Speed profile for car following tests

25th ACSF Informal group session

Tokyo, January 21-24, 2020

5.3.1. Following distance test (proposed modification)

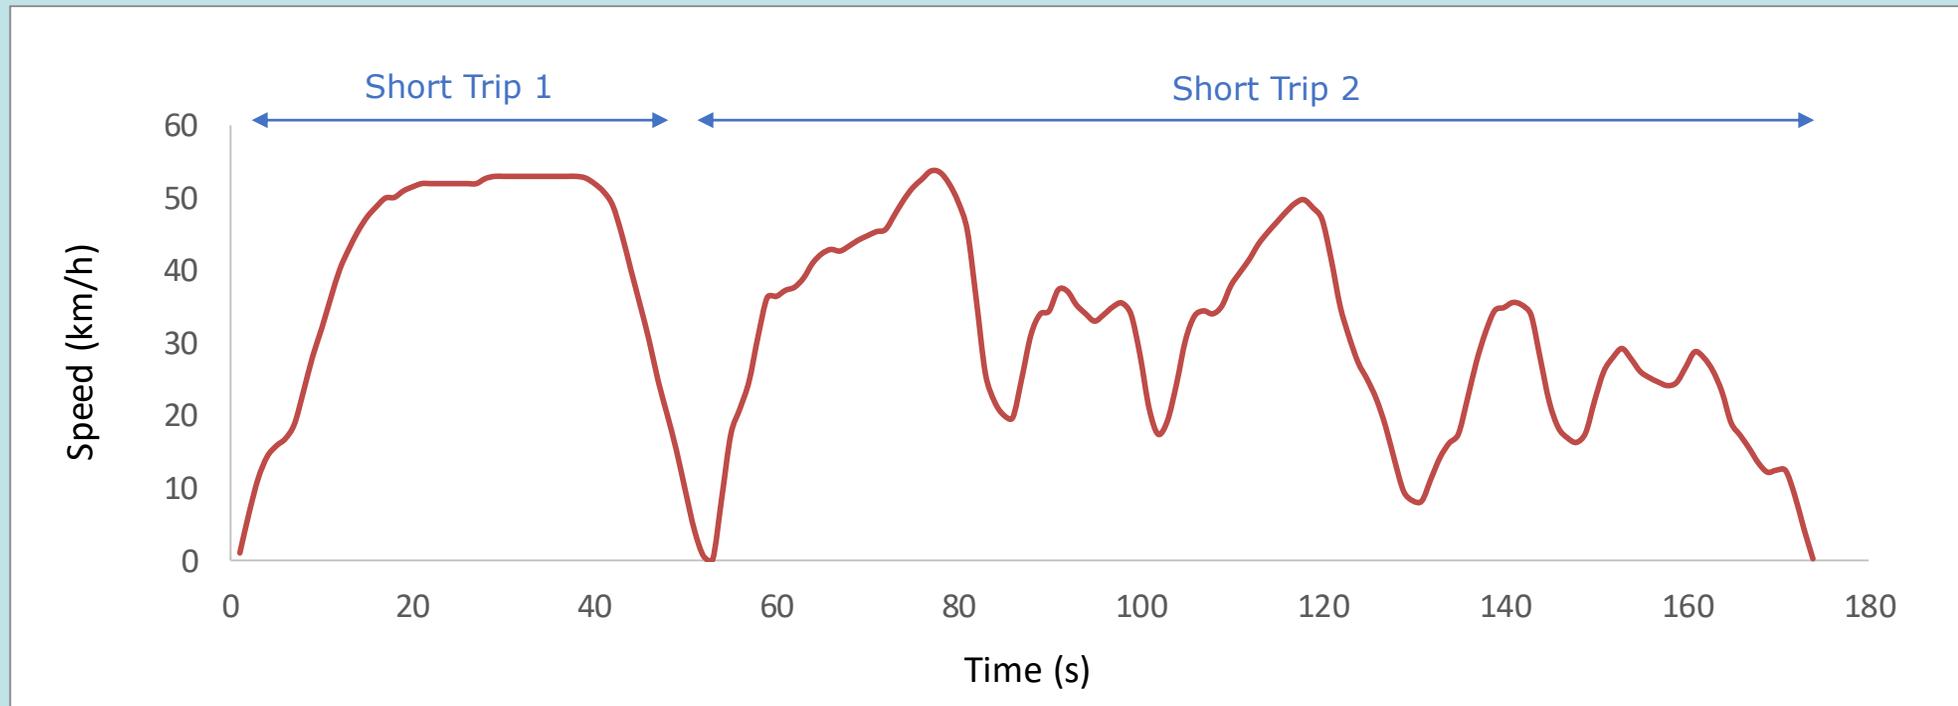
The preceding target shall be driven according to a realistic speed profile, including accelerations, decelerations and full stops, for a time longer than [3] minutes. The lead vehicle speed profile shall be randomly selected from the [**WLTP reference database***], according to the following algorithm:

- **Filtering** the database of short trips with defined parameter values (v_{\max} between [50] and [60] km/h, a_{\max} [4] m/s², a_{\min} [-4] m/s²)
- Performing a **weighted random selection** of the short trip from the filtered list, according to a weighting function [$v_{\text{average}} \times a_{\text{pos, average}}$], normalized by the sum of all the values, so that the total probability is 1.
- If the selected short trip has a duration below [3] minutes, more short trips shall be added until the total cycle duration reaches the minimum prescribed value.

5.3.1. Severe braking test (example)

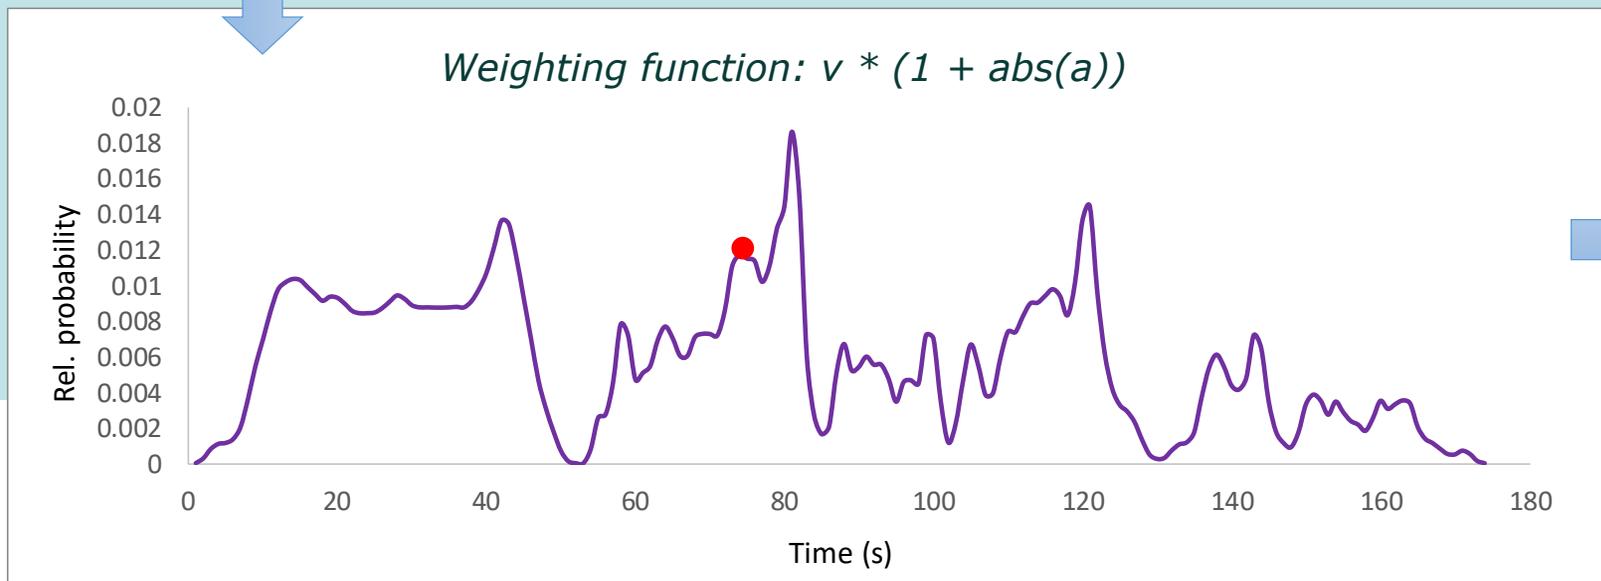
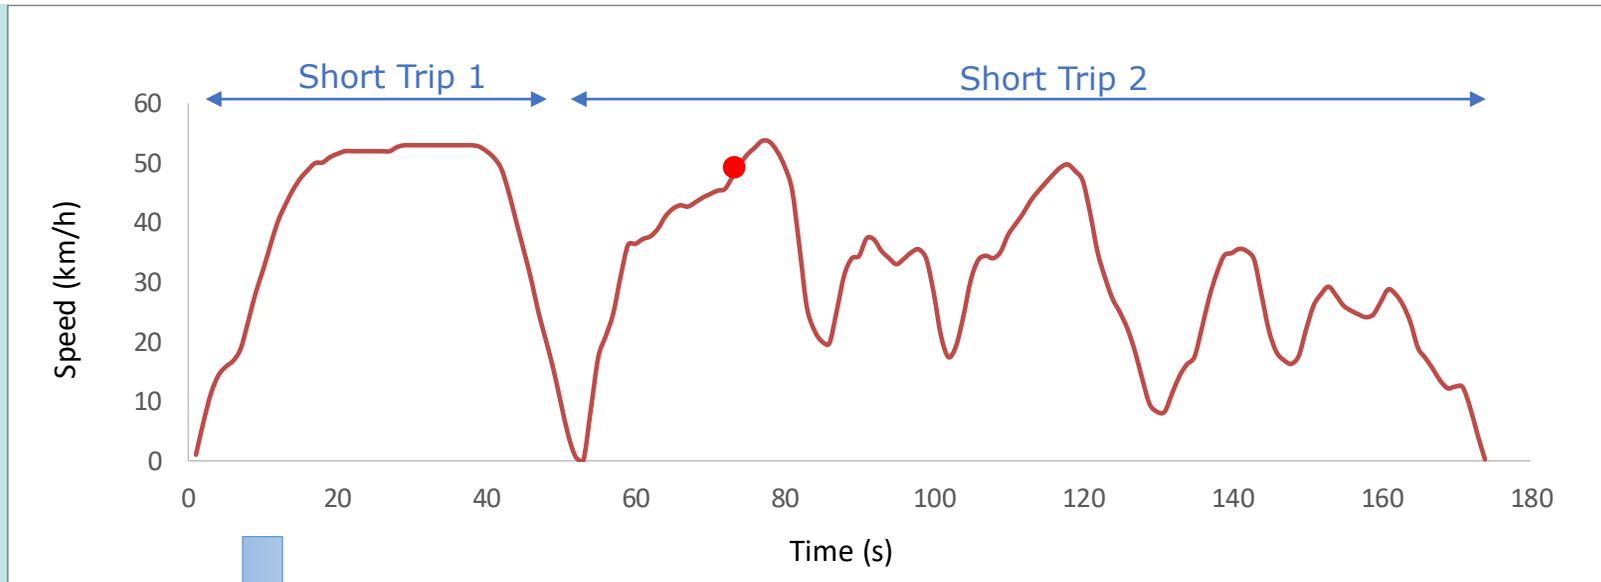
The preceding target shall be driven according to a realistic speed profile, including accelerations, decelerations and full stops. At time t_0 the preceding target will perform a deceleration maneuver with a mean fully developed deceleration of 6 m/s^2 until standstill. The lead vehicle speed profile and the time at which the deceleration starts shall be randomly selected, according to the following algorithm:

- **Random selection of the speed profile** as described in 5.3.1.
- **Weighted random selection** of the time of start of deceleration t_0 (which defines also the corresponding lead vehicle speed and acceleration v_0 and a_0) from the selected speed profile, according to a weighting function $[v \times (1 + \text{abs}(a))]$, normalised by the sum of all the values, so that the total probability is 1.
